TOWNPLANNING GROUP

29 April 2025

RESPONSE TO FURTHER INFORMATION REQUEST – RC240079 – 4663 STATE HIGHWAY 6, TE MIKO, PUNAKAIKI

Figure 2: Water Access Easement, identified as Area B

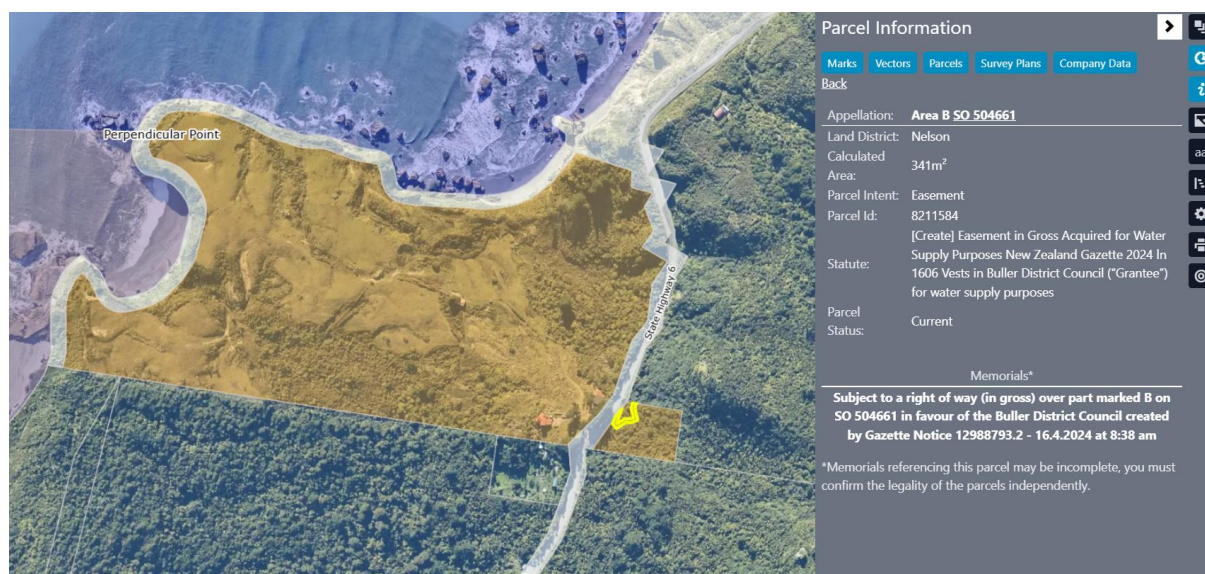
3. The application details "There is a single instrument registered on the Record of Title, with this relating to a right of way easement in favour of Buller District Council (Council), with this providing rights of access to their water supply infrastructure that serves Punakaiki". Please confirm/show where this is located.

A copy of the Gazette Notice 12988793.2 and SO 504661 is enclosed and appended as part of **Attachment [B]** to the revised AEE, with the easement area shown in **Figure 2**. This easement area is located on the opposite side of SH6 from the main development site.
